CONSTRUCTION STANDARD DRAWINGS

MEMORANDUM

To: All Users of the Roadway Construction Standard Drawings	**Date:** 20 Oct 04
From: Mary Viparina Assistant State Engineer Roadway Engineering Group	**Subject:** C-Standards Update

APPROVED FOR DESIGN	STATE OF ARIZONA DEPARTMENT OF TRANSPORTATION ROADWAY STANDARD DRAWINGS	REV. 9/04
APPROVED FOR DISTRIBUTION	FENCE FLOOD GATE INSTALLATION	DRAWING NO. C-12.10 Sheet 4 of 5

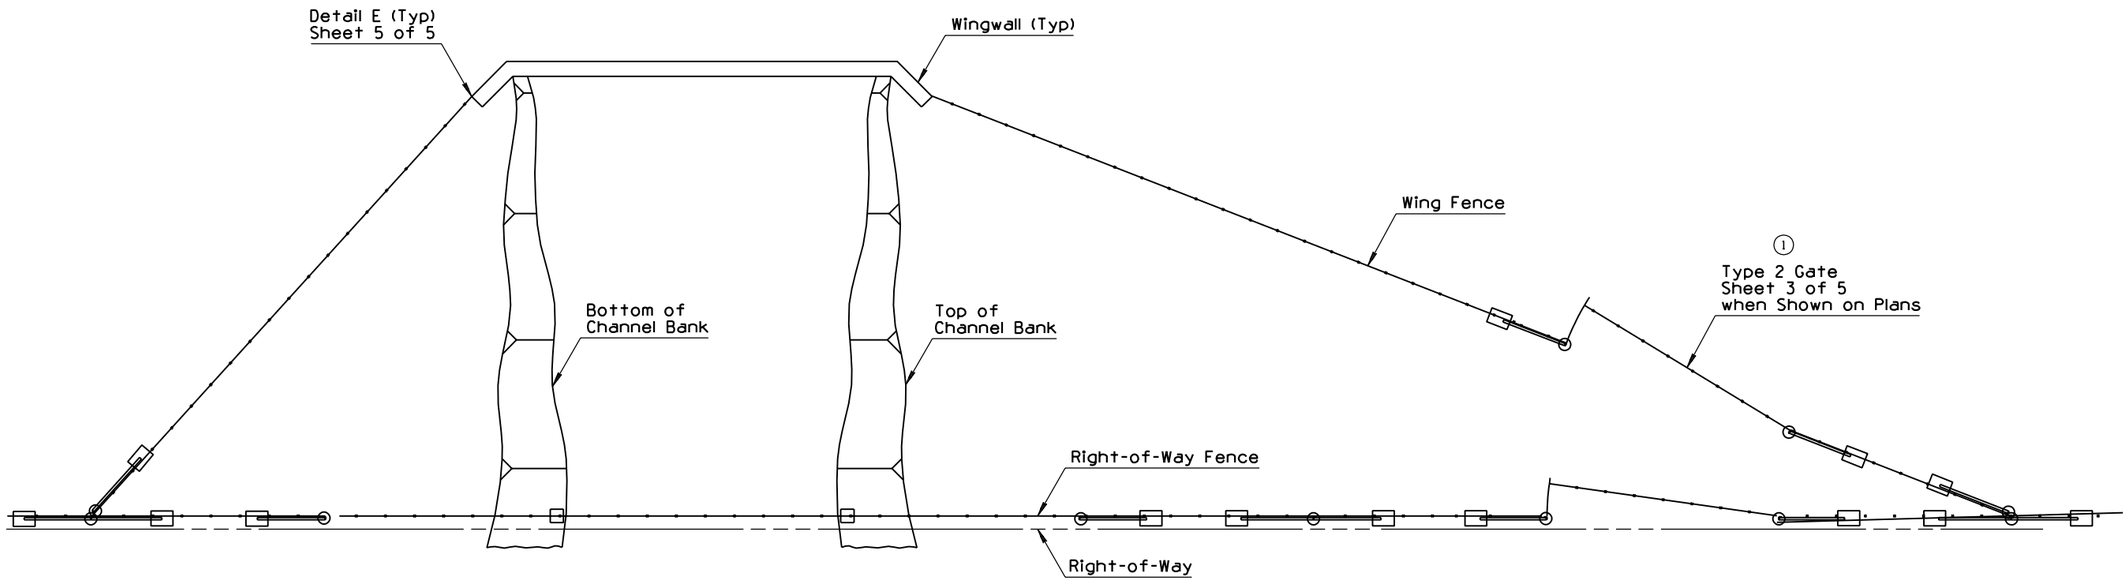
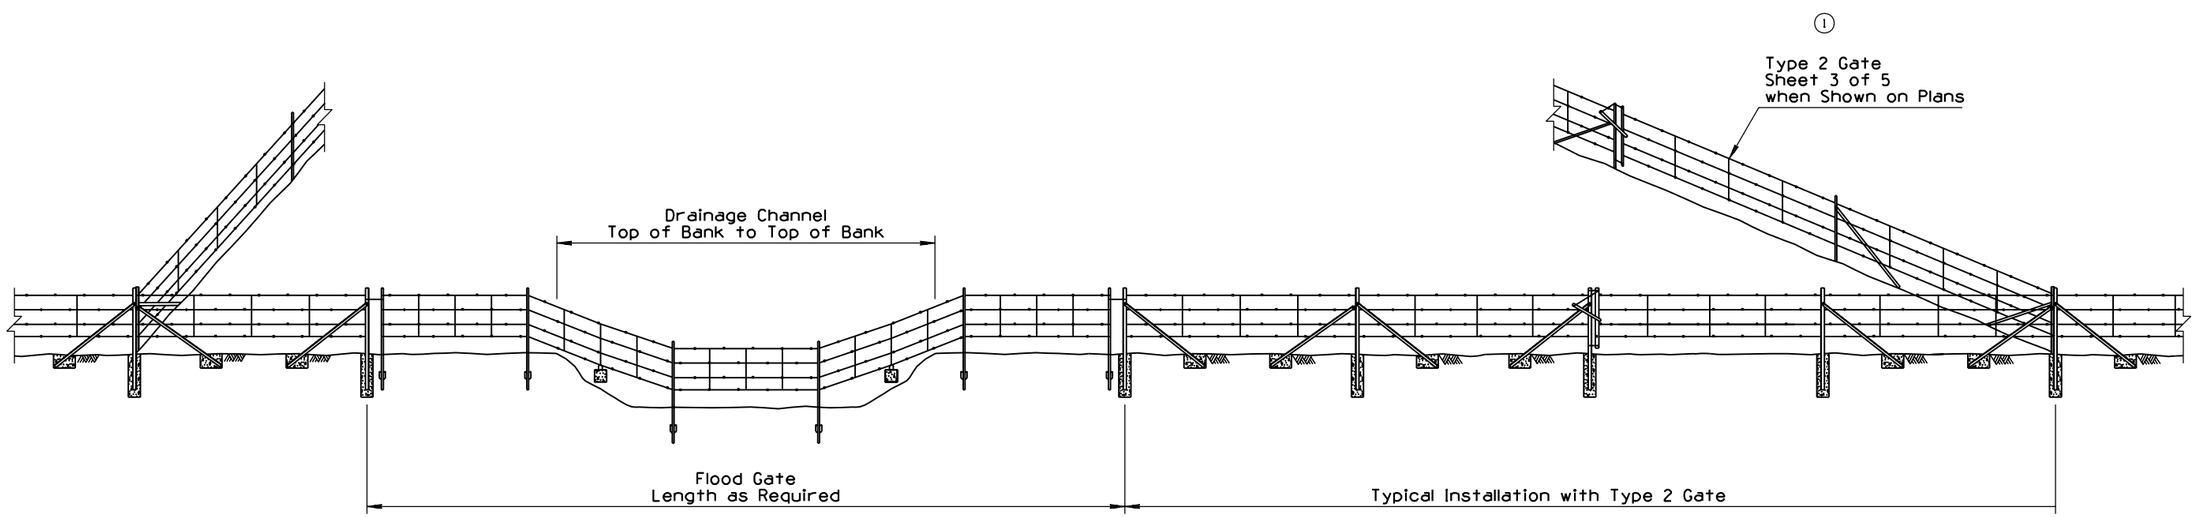
NO	DESCRIPTION OF REVISIONS	MADE BY	DATE
1	ADDED TYPE 2 GATE	RLF	9/04
2			
3			
4

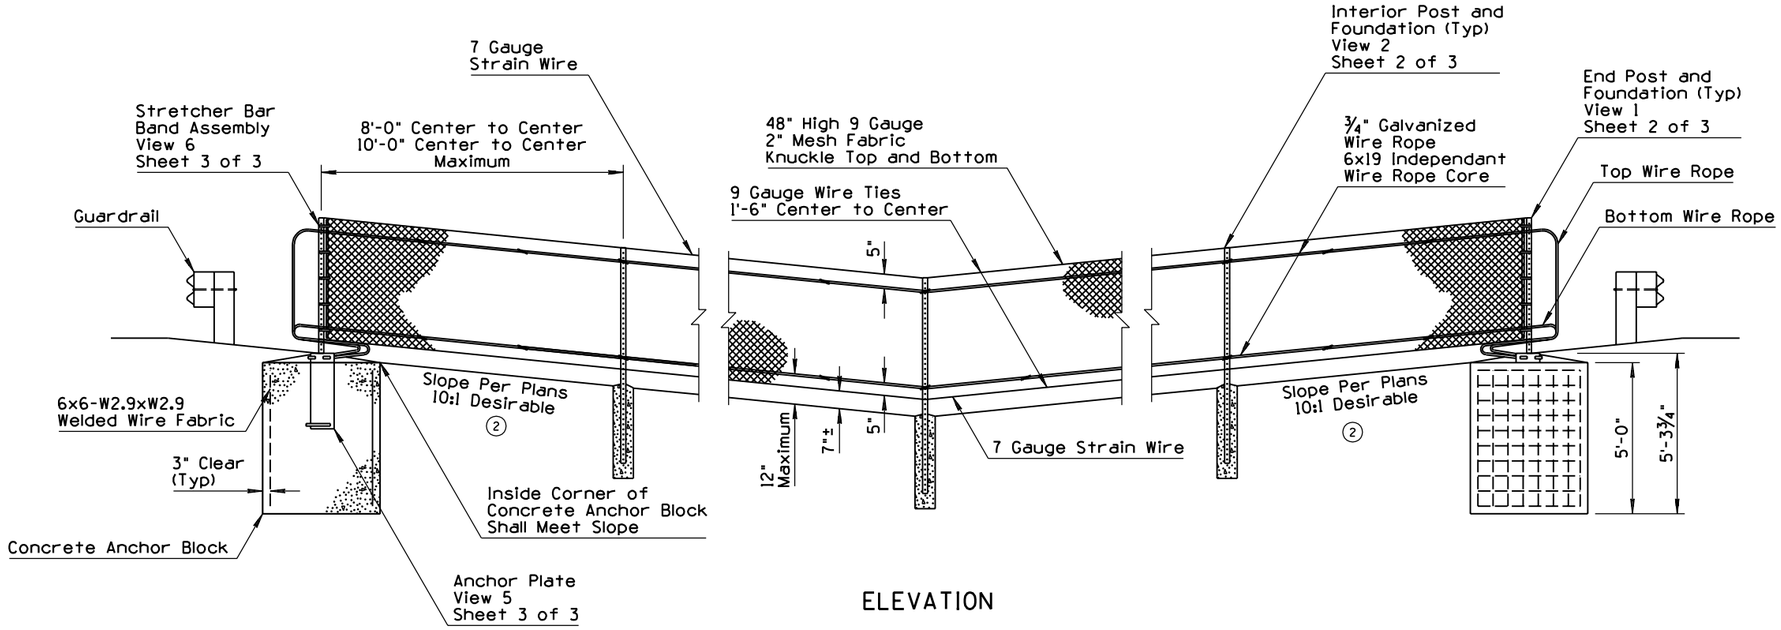
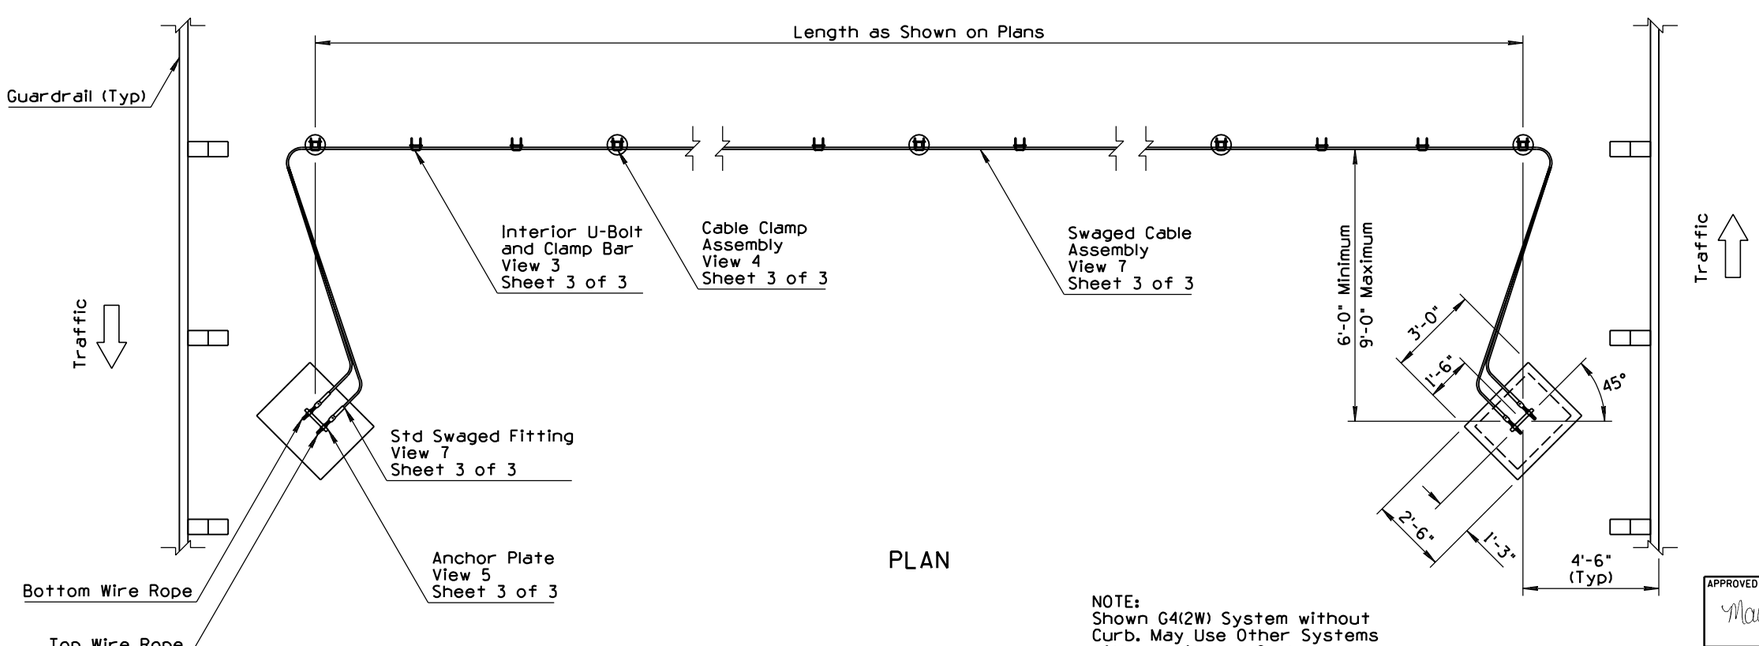
NO	DESCRIPTION OF REVISIONS	MADE BY	DATE
1	REVISED TITLE	RLF	9/04
2	REVISED SLOPE CRITERIA	RLF	9/04
3			
4
